Memorandum to the City of Markham Committee of Adjustment

File: A/053/23
Address: 69 Ingleborough Court, Markham
Applicant: Choo Chak Kwen & Yip Huan Seng
Agent: Ray Lall
Hearing Date: Wednesday, September 13, 2023

PROPOSED SITE PLAN
AUG 02, 2022

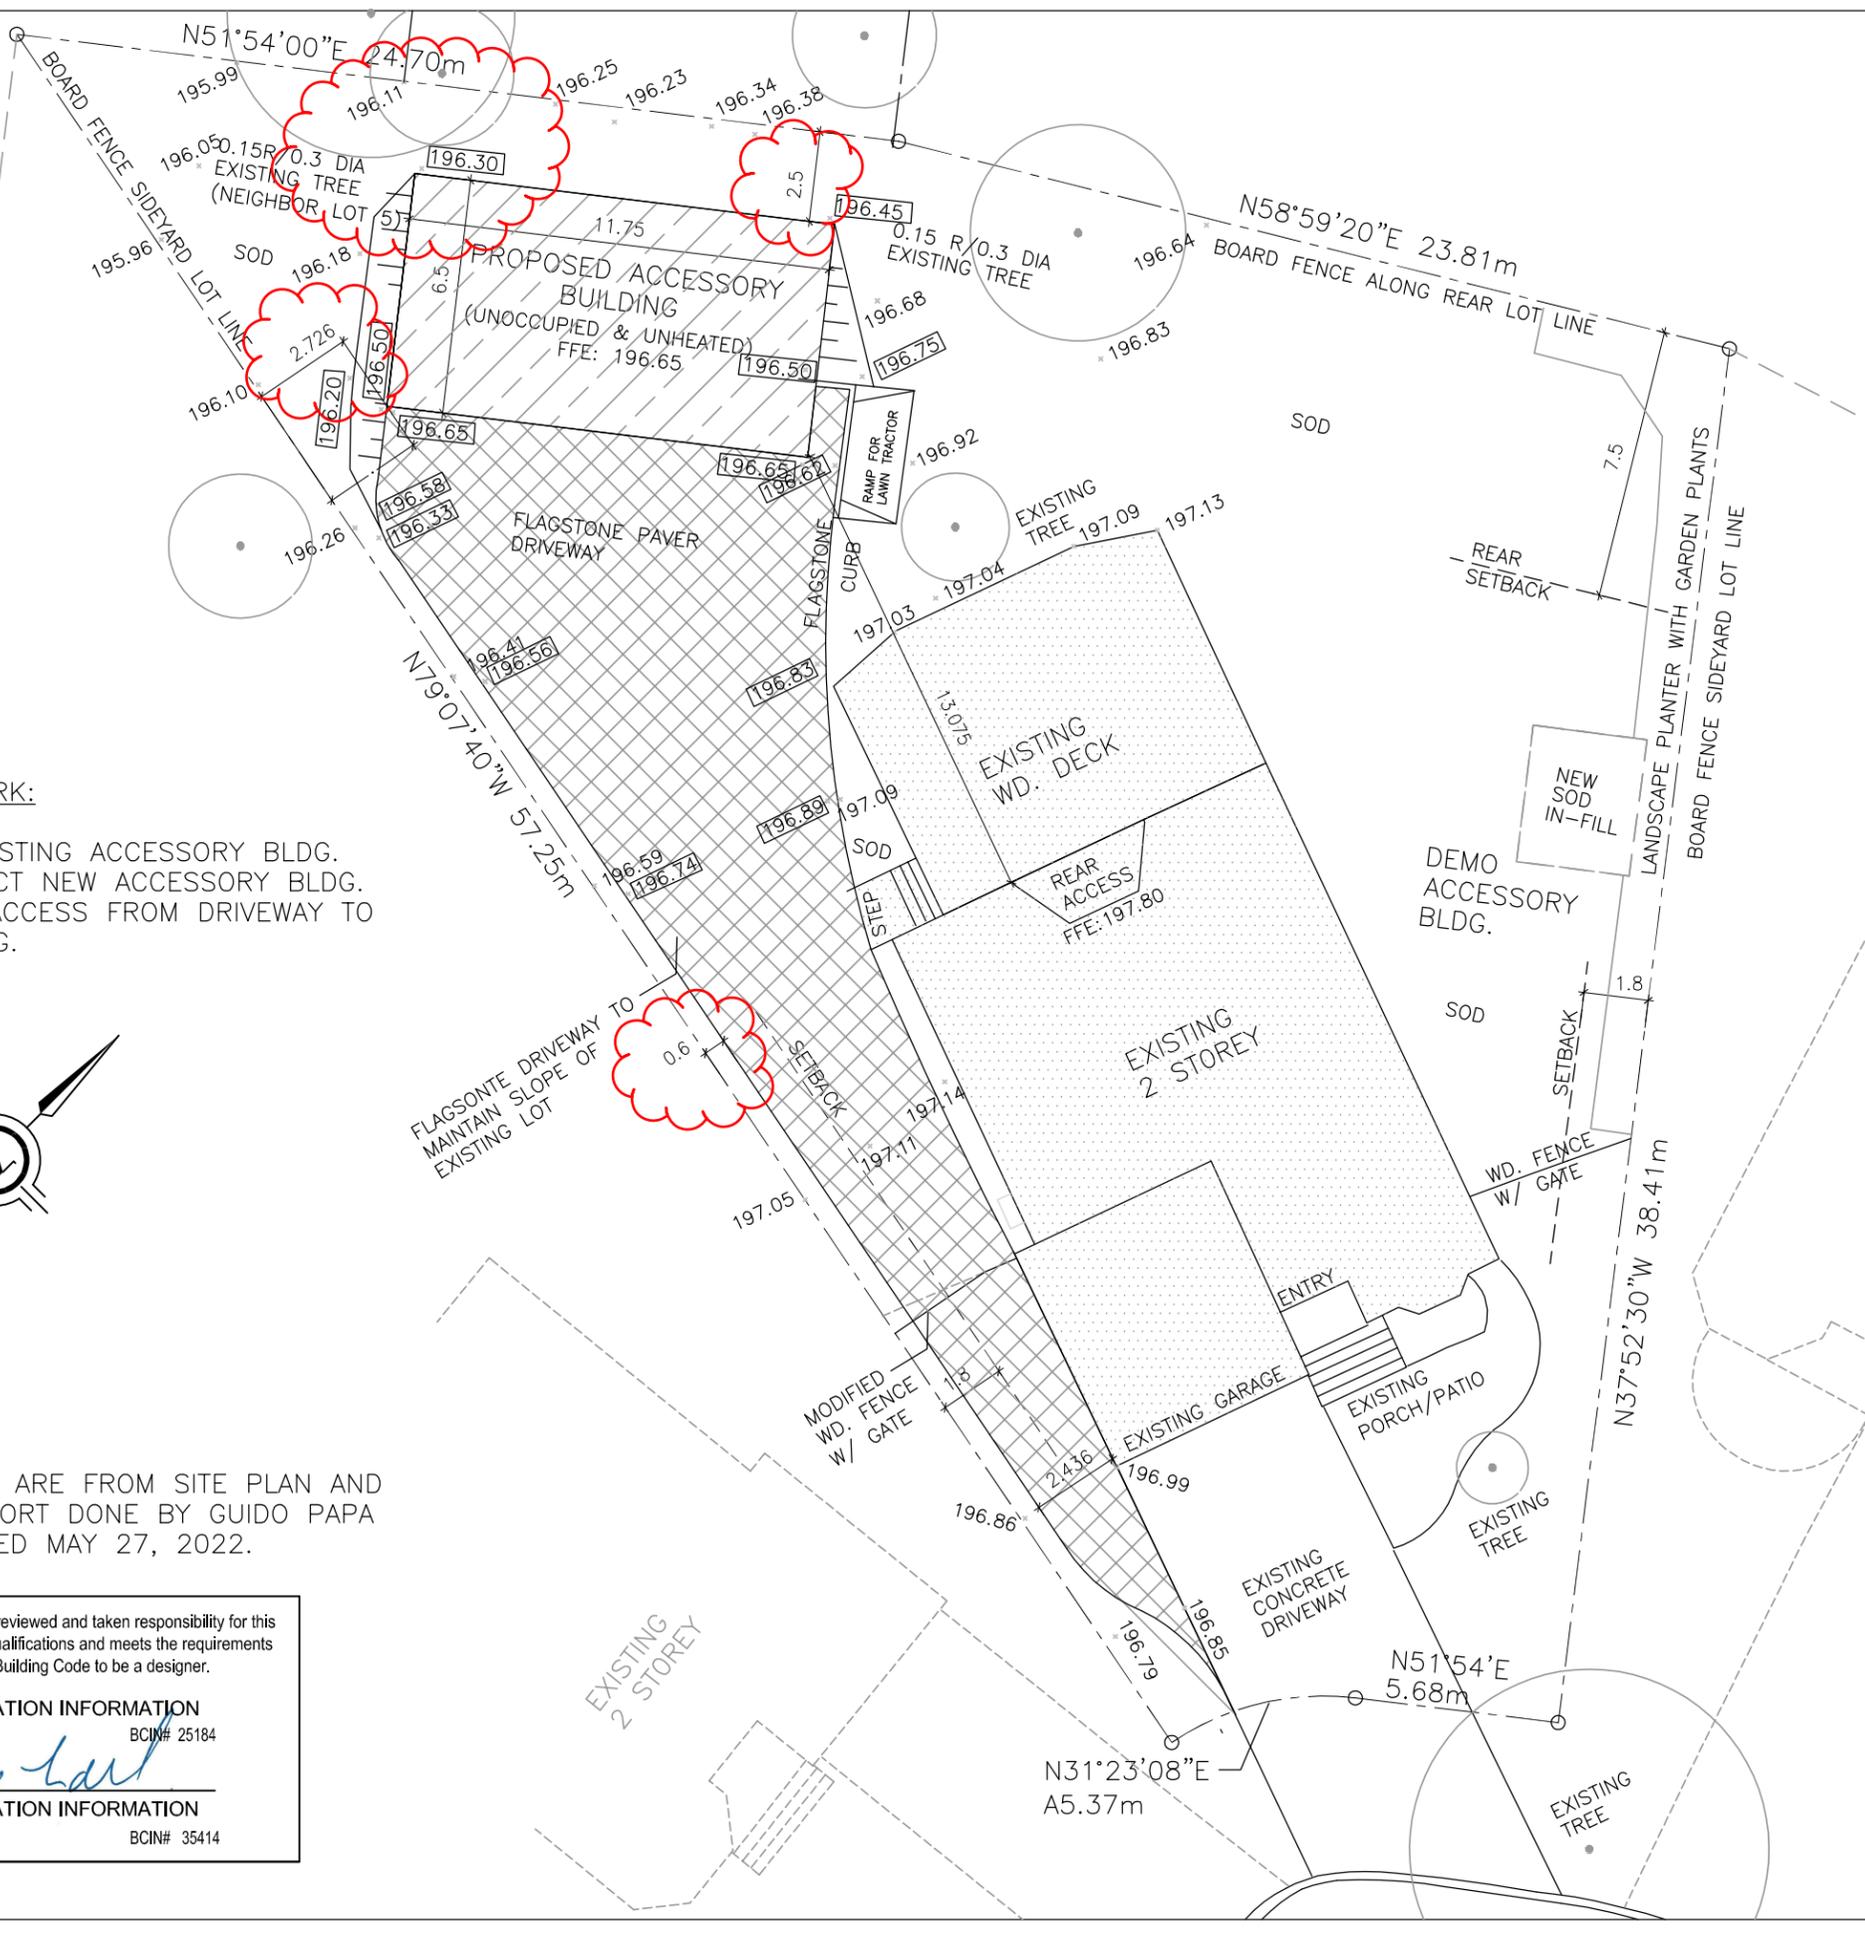
The Applicant is requesting relief for an accessory building to occupy 6.4 percent (76.4 m²) of the lot area, whereas the By-law permits an accessory building not to occupy more than 5 percent (57.5 m²) of the lot area. The proposed accessory building is designed solely for the purposes of vehicle parking and storage use. Staff are of the opinion that the proposed variance maintains appropriate accessory building lot coverage, is minor in nature and have no concern with the requested variance.

The Subject Lands contain mature vegetation in the rear and in the neighbouring rear lots. Tree Preservation staff had concern with the location of the proposed accessory building to impact two trees located in the neighbouring rear lots. The Applicant revised

their plans to respond to Tree Preservation staff to reduce impacts from the proposed accessory building.

The Applicant originally requested a minimum interior side yard driveway setback of 0.27 m, whereas the by-law requires a minimum of 0.6 m driveway setback along the side yard of the property line.

Engineering staff could not support the initial requested variance b) as it relates to an interior side yard driveway setback. Section F2 of the Engineering Design Criteria ensures that proper surface drainage and maximised usable land area is provided. Under Section F2.1 of the design criteria, it indicates that “a minimum of 0.6 m of undisturbed strip shall be required where abutting lots exists”. Consequently, when the Applicant proceeds with a Residential Infill Grading and Servicing (RGS) application in the future, the requested variance b) will not satisfy the requirements under the Engineering Design Criteria and will require the Applicant to redesign the proposed driveway.

As a result, the Applicant revised the proposal to align with the Engineering Design Criteria to ensure that the future RGS submission will be accepted. The Applicant no longer required the initial requested variance b) for interior side yard driveway setback.
